APPLICATION FOR SOIL INVESTIGATION

SITE INVESTIGATION REPORT
INDIVIDUAL SEPTIC TANK SYSTEM
WITH SUBSURFACE,
SOIL ABSORPTION,
EFFLUENT DISCHARGE

APPENDIX H
SITE EVALUATION

SITE INVESTIGATION REPORT
INDIVIDUAL SEPTIC TANK SYSTEM
WITH SUBSURFACE,
SOIL ABSORPTION,
EFFLUENT DISCHARGE

7) ACCURATELY DIAGRAM & DIMENSION LOT

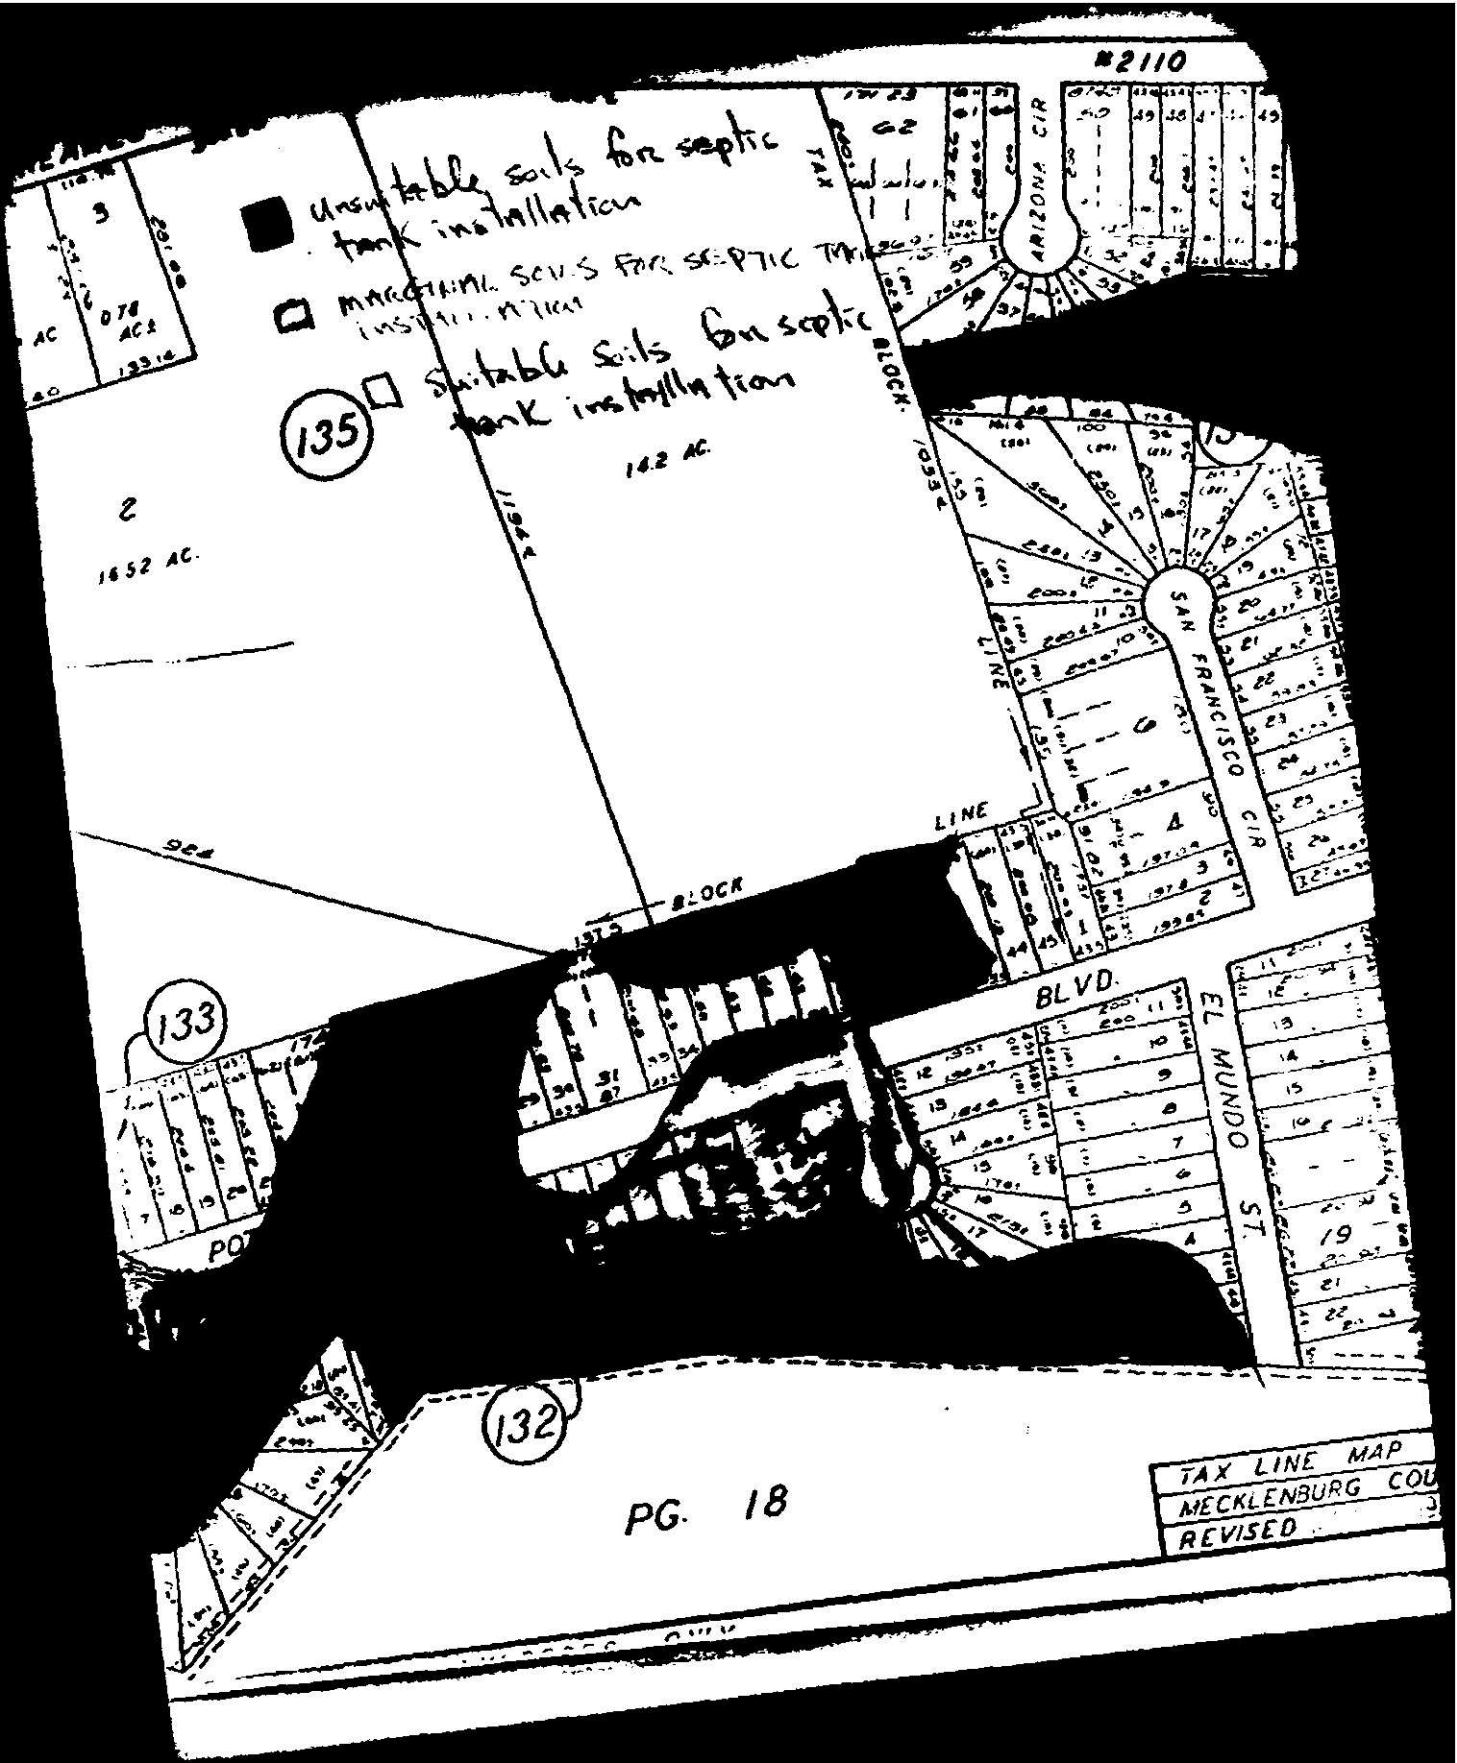
#2110
Unsuitable soils for septic tank installation
MARGINAL SOILS FOR SEPTIC TANK INSTALLATION
Suitable Soils for septic tank installation
14.2 AC.
16.52 AC.
135
133
132
ARIZONA CIR
SAN FRANCISCO CIR
EL MUNDO ST.
BLVD.
BLOCK
LINE
TAX LINE MAP
MECKLENBURG COU
REVISED
PG. 18

As determined under the Rules and Regulations promulgated by the Commission for Health Services, Division of Health Services, North Carolina Department of Human Resources, Raleigh, North Carolina, the soils on the lot described above were found to be unsuitable for the installation of an individual septic tank-soil absorption system. This site cannot be approved for a septic tank system due to the following reason:

Soil structure massive

Inadequate area available for installation of ground absorption sewage disposal system in accordance with North Carolina Department of Human Resources specifications.

* See Diagram on Back (Include: Soil areas, property lines, roads, streams, gullies, wet areas, fill areas, wells, water bodies, slope patterns, etc)

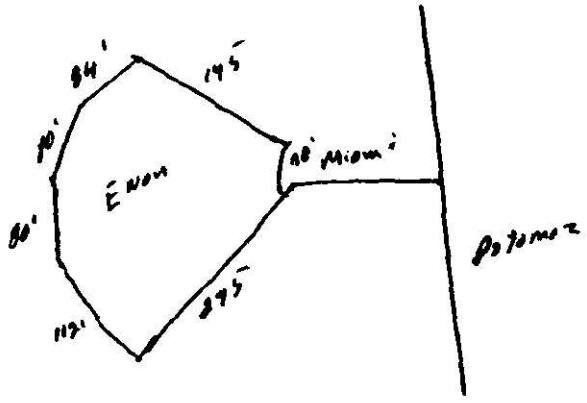
FACTORS	AREA 1	AREA 2	AREA 3	AREA 4
1. SLOPE (%)	(S) PS 2-8% U	S PS U	S PS U	S PS U
2. SOIL TEXTURE (12-36 in.) (Sandy, loamy, clayey, Note 2:1, Clay)	S PS 2-1 (U) Clay	S PS U	S PS U	S PS U
3. SOIL STRUCTURE (12.36 in.) (Clayey Soils)	S Massive PS (U)	S PS U	S PS U	S PS U
4. SOIL DEPTH (In.)	(S) 48" PS U	S PS U	S PS U	S PS U
5. RESTRICTIVE HORIZONS (In.) (Imprevious Strata, Rock)	(S) None PS U	S PS U	S PS U	S PS U
6. SOIL DRAINAGE/GROUNDWATER (External & Internal)	(S) 76" to PS ground U water	S PS U	S PS U	S PS U
7. SOIL PERMEABILITY (Percolation Rate)	S Slow PS Very (U) slow	S PS U	S PS U	S PS U
8. OTHER (Specify)	S PS U	S PS U	S PS U	S PS U
9. SITE CLASSIFICATION	unsuitable			
SOIL SERIES	Enon

Soil Structure Massive
Soil Permeability Unsuitable

Section 10 fo the North Carolina Administrative Code 10A, .1910 of these regulations states "Sites originally classified as unsuitable may be used for soil absorption disposal systems, provided engineering, hydrogeologic, and soils studies indicate to the local agency that a suitable alternate system can reasonably be expected to function satisfactorily.

These regulations became effective July 1, 1977. Since that time the second sentence of Section .1910(c) has been found to be nugatory. For this reason, if you desire to file for permission to install an "alternate" system you should present this office with your proposals in the form of plans and specifications. These would be reviewed and if it is found that the system may reasonably be expected to function satisfactorily approval may be given on the execution by you of a "Septic Tank Agreement Form" available in this office.
